AUDIT REPORT
OF
“NORTHERN EAST-WEST HIGHWAY PROJECT”
IMPLEMENTED BY
REGIONAL OFFICE, LINGMETHANG, DEPARTMENT OF ROADS,
MINISTRY OF WORKS AND HUMAN SETTLEMENT

PERIOD: INCEPTION TO 30 JUNE 2017

Subject: Audit Report of “Northern East west Highway Project” of Regional Office, Lingmethang for the period from inception to 30.6.2017

Fig: 2.1(1)-Revised design and drawing

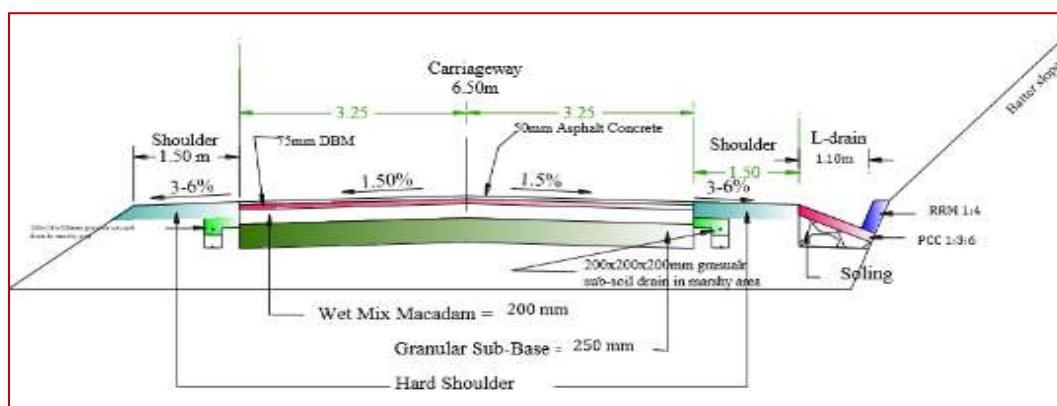
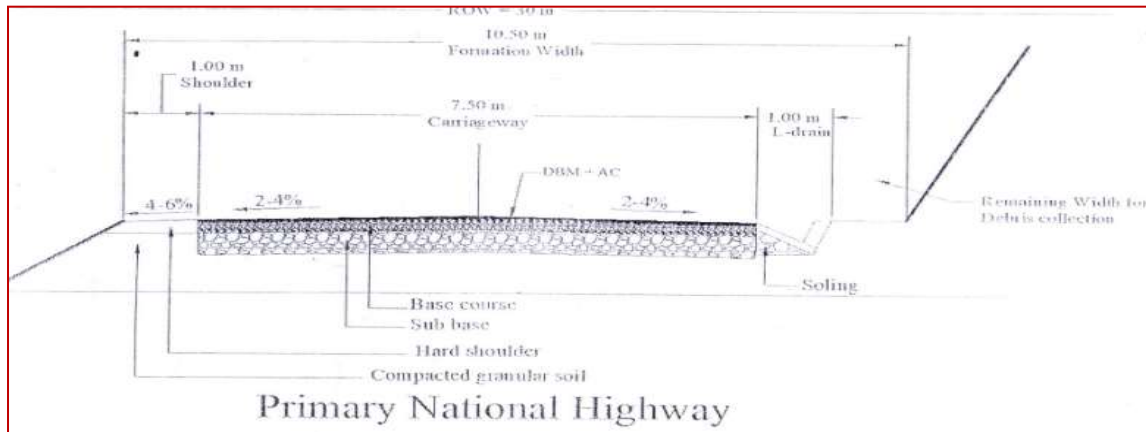
However, vide letter No. MoWHS/Sec-29/2015-2016/524 dated 16th October 2015, the Secretary, MoWHS had conveyed the meeting held on **16th June 2015** with the contractors and directed the Regional Offices for issuance of amendment to the contract agreements based on the decisions subsequently taken to increase the carriageway width from 6.5m to 7.5 m. Reasons for increase of carriageway width was found not documented.

In addition, vide letter No. DoR/ROL/16/15-16/481 dated 21/10/15, all Regional Offices were informed to increase the pavement width from 6.5 meters to 7.5 meters. In line with change order, the revised drawing developed and circulated by Design Division, DoR Thimphu was as depicted in the photograph below:

Thus, the increase of pavement width of 1m from the initial carriageway width of 6.5m to 7.5m after a time lapse of almost eight months from the dates of awards of contract works was irrational and inappropriate as it had not only distorted the drawings, estimates, BOQs, Projected Cost and funding modality but also adversely impacted the overall project cost by **Nu. 317,636,875.54** as summarized in table 2.1 below:

The Regional Offices in consultation with the Ministry should comment on the changes of drawings and technical specifications after the awards of contract works that had resulted in additional avoidable financial implication to the extent of **Nu. 317,636,875.54**.

The Ministry should not only strengthen the Design Divisions for accurate designing of road structures but also institute a technical team to review project plans, designs, and specifications to ensure that the same are accurate and complete including verification of the accuracy of surveys for future projects as to prevent changes in designs as well as time and cost overruns.

Figure 1.5(2): Revised drawing No. 1: Pavement drawing followed by RO Lobeysa and Lingmethang

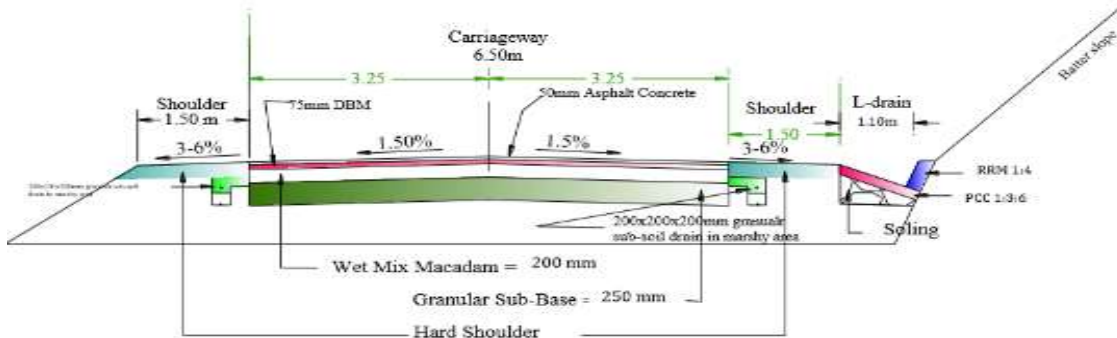
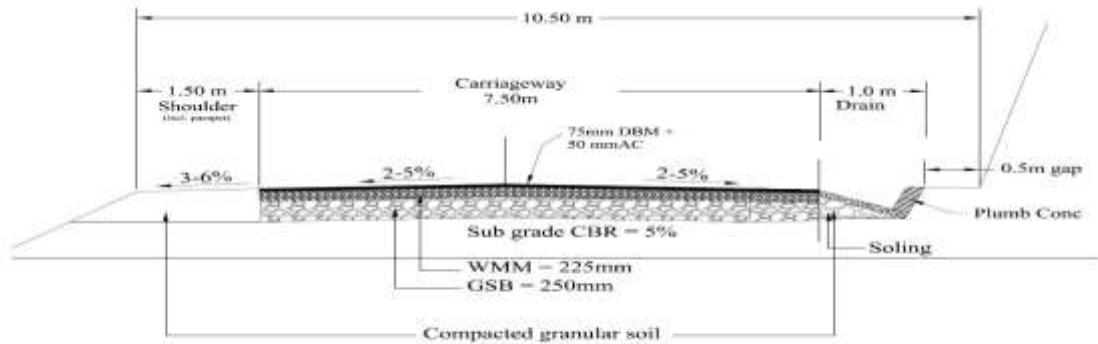
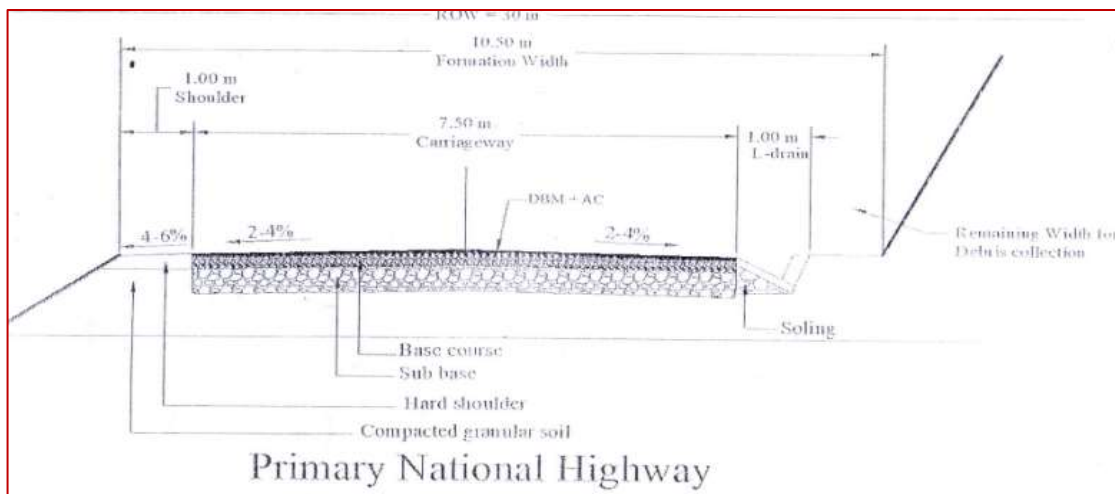
However, the Secretary, MoWHS vide letter No. MoWHS/Sec-29/2015-16/524 dated 16th October 2015 amongst others, directed all the Regional Offices on the decisions taken during the meeting held on February, 2016, after a time elapse of more than eight months from the commencement of the contract works, to increase pavement width from 6.5 m to 7.5 m and to issue amendment to the contract agreement signed with the contractors under respective jurisdictions.

In line with change order, the revised drawing was developed and circulated by Design Division, DoR Thimphu. However, during the course of the review of drawings implemented by the four Regional Offices, and site verifications, the audit team noted two (2) different drawings with difference technical specification for the same NEWH Up-gradation works.

It was noted that RO Thimphu and Trongsa were following one drawing and RO Lobeysa and Lingmethang were following a different as shown in Figure 1 & 2 below:

Adoption of two different drawings with varying pavement specifications and non-adherence to the approved Road Design Standard indicated improper planning and lack of due diligence in the preparation of drawings and specifications. Such mismatches in technical specification of road works would inevitably result in execution of two different type of pavement works for the same NEWH double lanning works.

The ministry should review the circumstances leading to the implementation of two different sets of designs by the ROs besides instituting design review process to ensure consistent and uniform implementation of designs and drawing for similar projects in future.

In addition, the Ministry should also revisit the revised designs circulated to ROs, as the requisite gap between hillside and drains was found not maintained in majority of the work due to site specific and alignment problem of the drain works. Further, the Ministry should also relook on doing away of 1.5m Hard shoulders between the L-Drain and Carriageway in terms of risks towards safety of the commuters.

Fig: 2.6(2)- Revised design and drawing

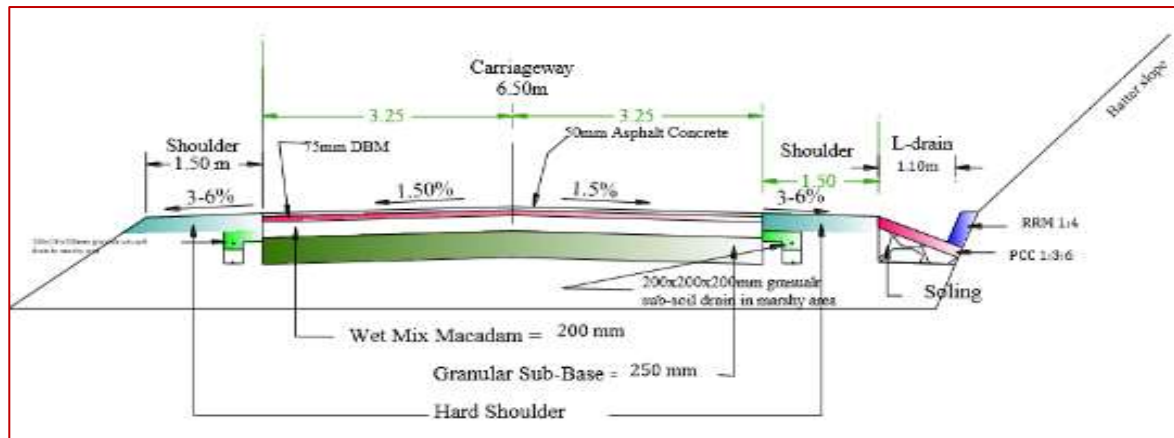
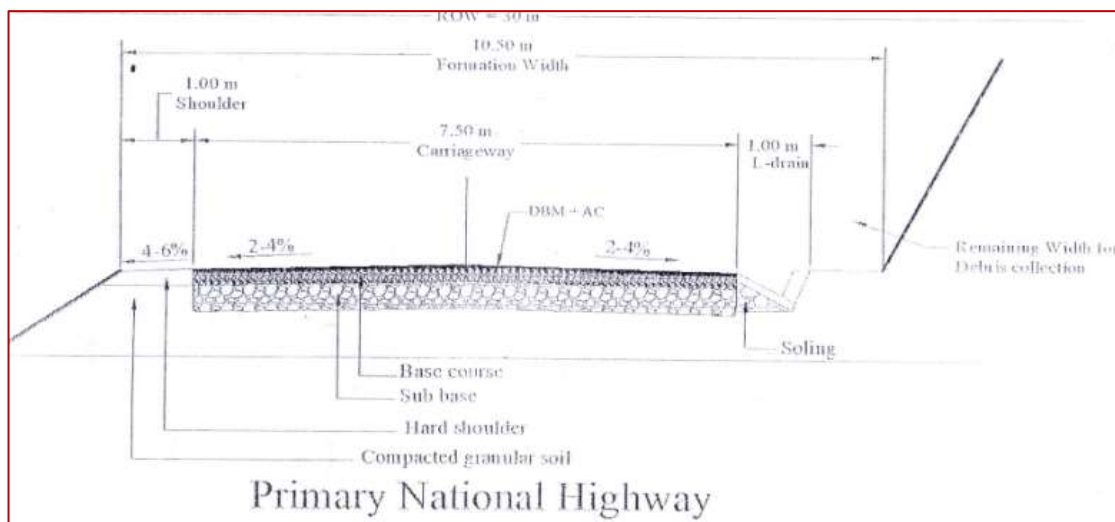
While the subsequent design and drawing had maintained increased carriage pavement width of 7.5m, other structural drawings were also changed from the initial designs and drawings as evident from the above photograph.

The above changes in the design and drawing not only resulted in extra financial implication to the government exchequer for increase of 1m carriage width to the extent of approximately Nu.317.637 million but also impeded timely completion of work due to grant of time extension for the increased scope of work as well as compromised safety measures by doing away Hard shoulders of 1.5m width between the L-Drain and Paved carriageway width including reduction of 0.5m hard shoulder at valley side. Besides, due to design changes, overall formation width of 10.5m were found not achieved as 1m width supposedly maintained for Debris collections between hillside and L-Drain were found not maintained in entirety for all stretches of the roads as majority of the L-Drain was found constructed attached to the hillside. Further, 1m shoulder width on the valley sides were also found not maintained as in some stretches of roads the pavement road were found executed at the edge of the road width.

As discussed in the exit meeting, the DOR in consultation with the Ministry should revisit the revised drawing for appropriate decisions and taking measures to address any technical flaws and ambiguities. Besides, the Ministry should also look in to the requirement of approval of

Cabinet on the revised designs as it had deviated from “The Guidelines on Road Classification System and Delineation of Construction and Maintenance Responsibilities 2009”.

Fig: 2.22- Initial approved design and drawing

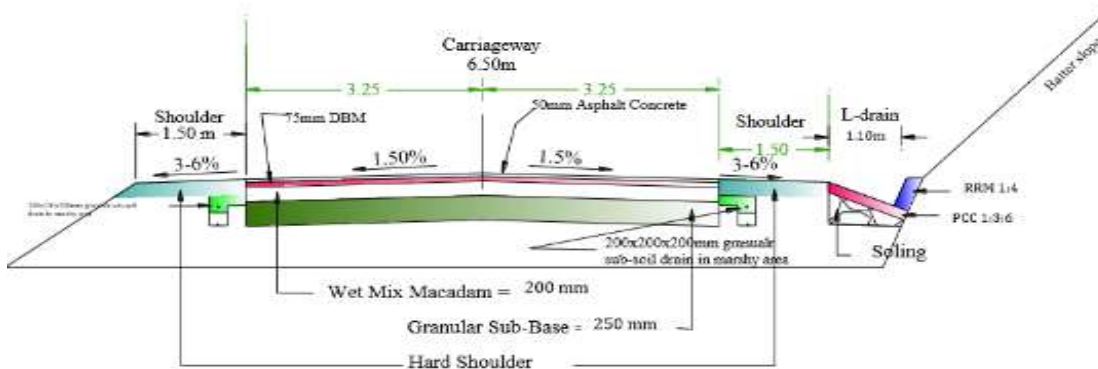
2.23 Irregular Change of pavement thickness with resultant inconsistency in the execution of pavement works

Northern East-West Highway being the Primary National Highway, both the initial and revised drawings has specified a total pavement thickness of 600mm as shown in the diagram and in the table below:
